Value Engineering Study

Final Report

VE Number: 202303

I-75 Widening, MP 20.2 to MP 28.851 Laurel & Whitley Counties

24

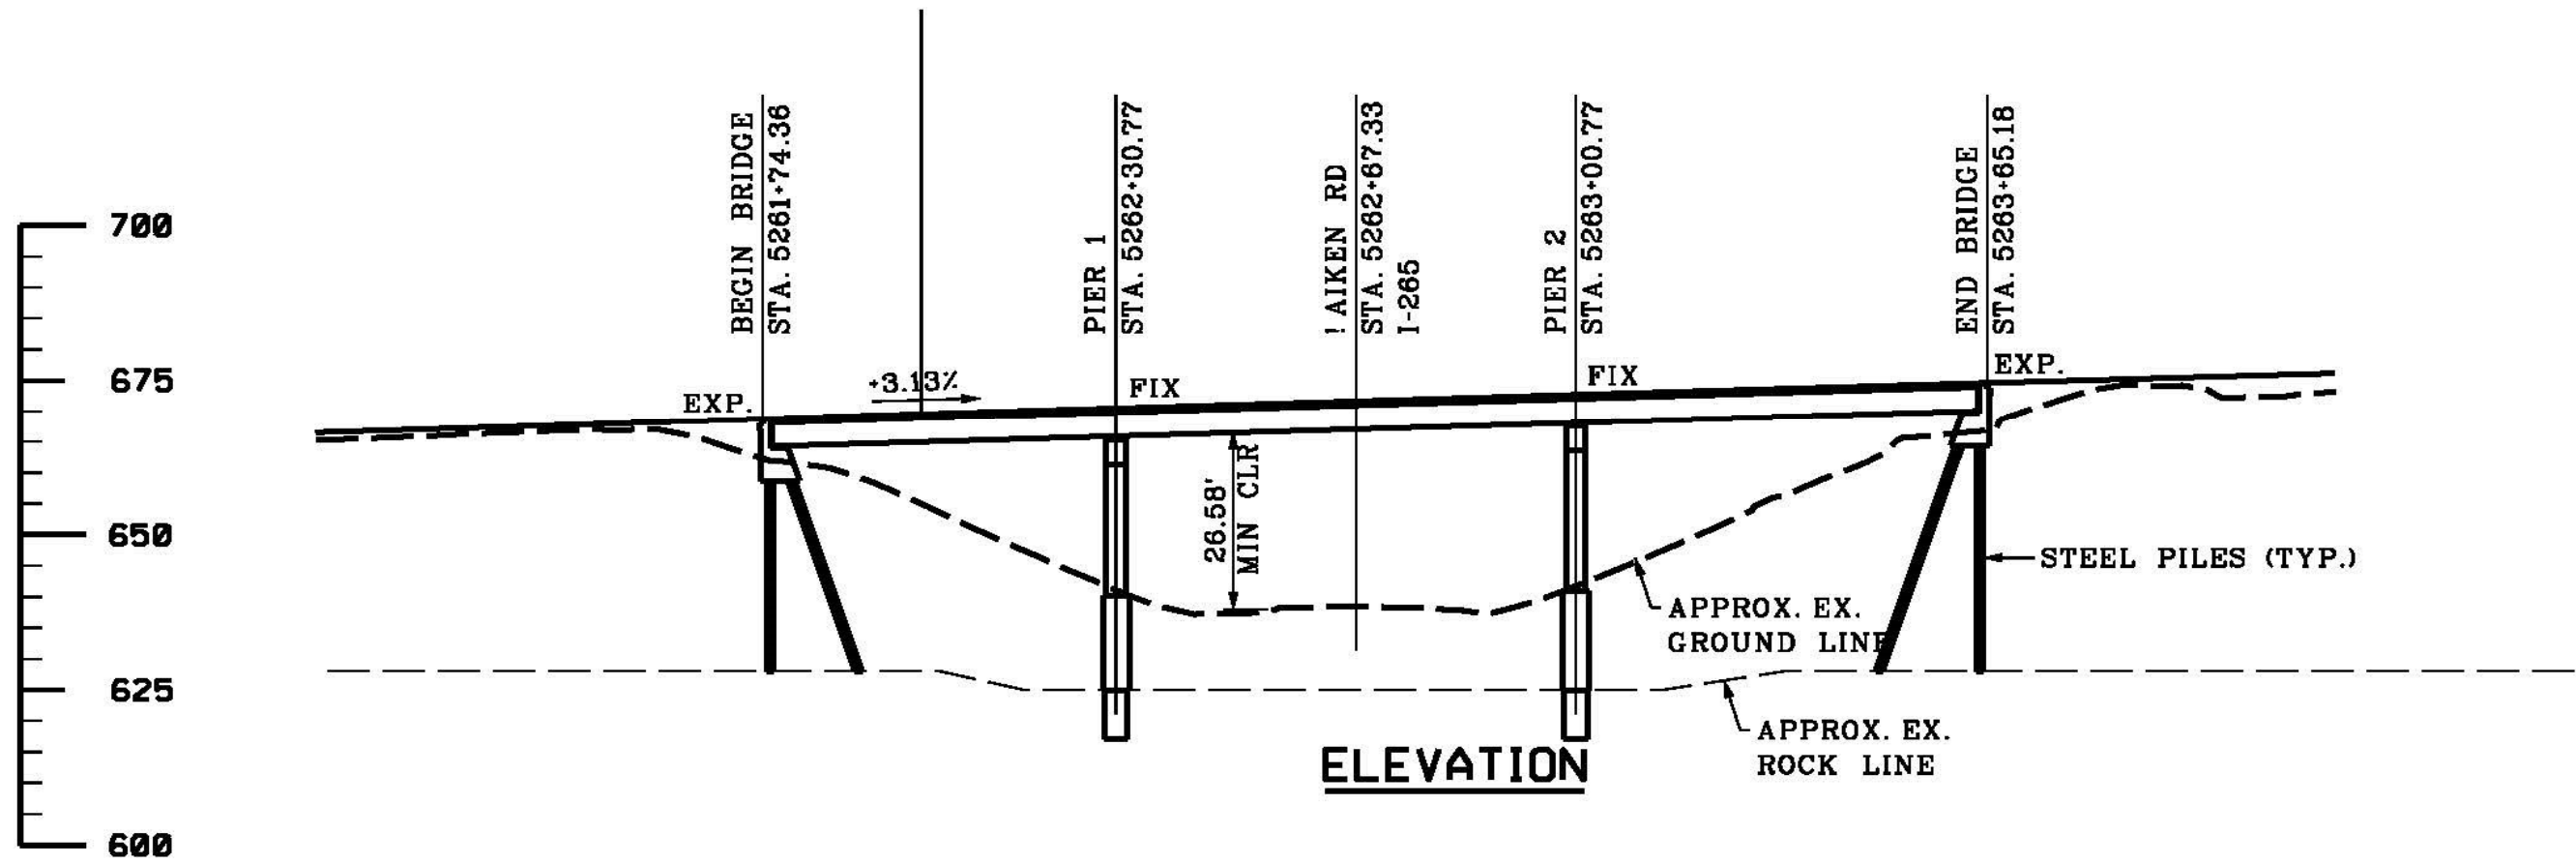
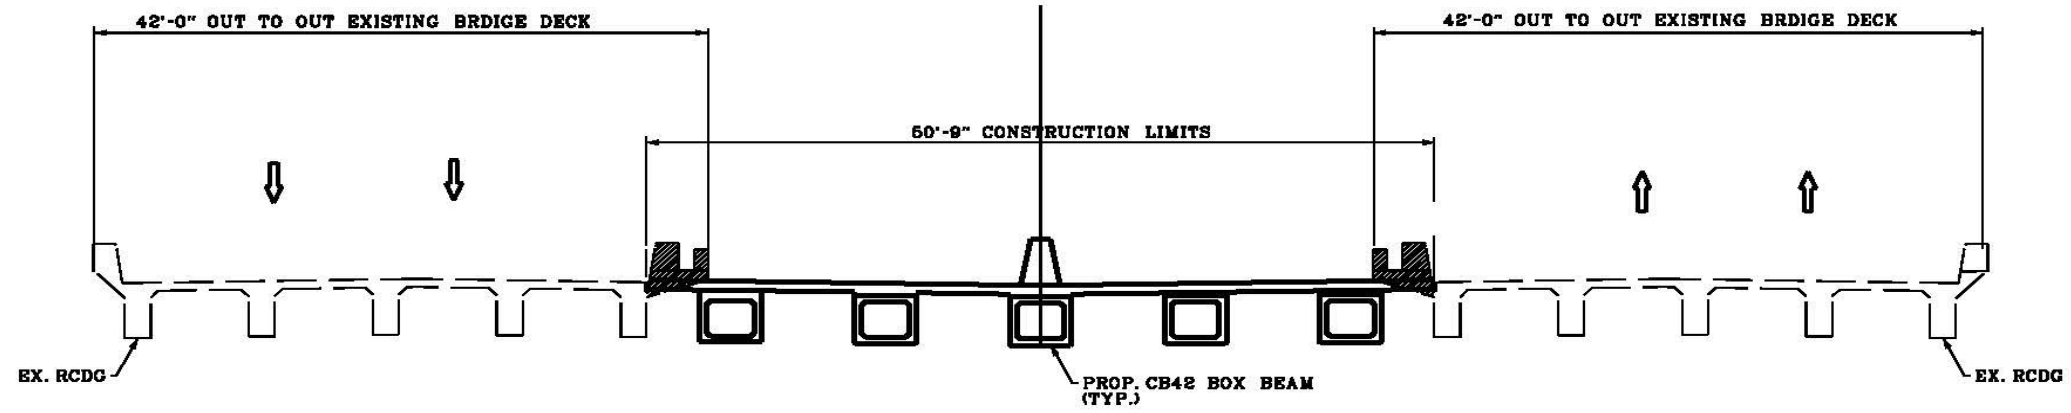
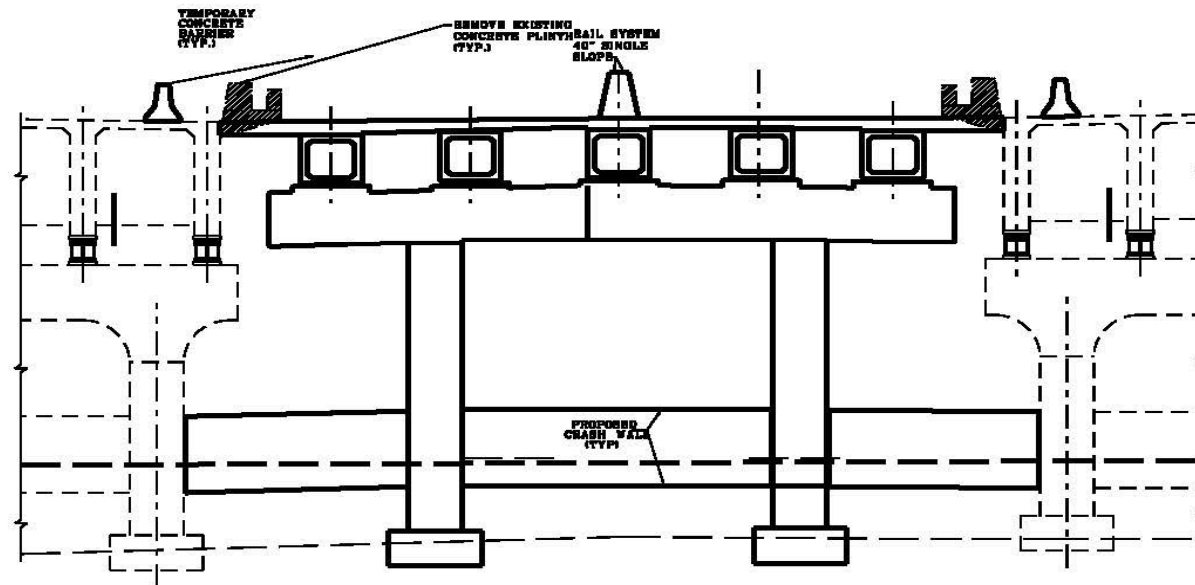
TITLE	For the bridge over KY727, build additional piers to build a bridge between the existing two bridges, and rehab the existing bridge structure		
VALUE PROPOSAL SYNOPSIS:			
The existing bridge can be utilized in the widen bridge and reduce the cost of removing the existing bridge and building a wider new bridge.			
 Reliability	Maintained	 Functionality	Maintained
 O&M	Maintained	 Schedule Impact	Improved
			\$ Initial Cost Avoidance (Add)
			\$2,474,000
BASELINE CONCEPT:			
A new bridge (3span PCI beam) designed to the current specifications would be the constructed at this site. The orginial bridge will need to be removed.			
VALUE PROPOSAL DESCRIPTION:			
The existing bridge is a twin continuous RCDG bridge. This bridge style has a history of low on going maintenance cost and has robust load carrying traits (eventhough designed to HS20). Intergrating the existing bridges in the final structure saves considerable construction cost by only constructing a widen portion to the middle.

TITLE	For the bridge over KY727, build additional piers to build a bridge between the existing two bridges, and rehab the existing bridge structure
DISCUSSION & JUSTIFICATION:	
<p>The information provided by the project team led the value team to conclude the baseline design for the KY 727 structure would be to remove and replace with a new structure meeting current design criteria. Based on the information the value team has, we believe current vertical clearances are sufficient for the structure. The existing structure is a twin continuous RCDG bridge which, depending on analysis, appears to be in good condition.</p> <p>The value team proposes constructing and integrating a new structure between the two existing structures and strengthening the existing structures to obtain the desired load rating. The history of the RCDG bridges have proven them to be low maintenance structures that have weathered the course of time to still thrive as reliable dependable bridges today. With some strengthening of the structure the HS20 design can be brought up to current standards.</p> <p>By not having to replace these two structures, the bridge at KY 727 can be constructed much more quickly with less traffic shifts, less materials, shorter construction time, less cost, and much less impacts to the traveling public.</p>
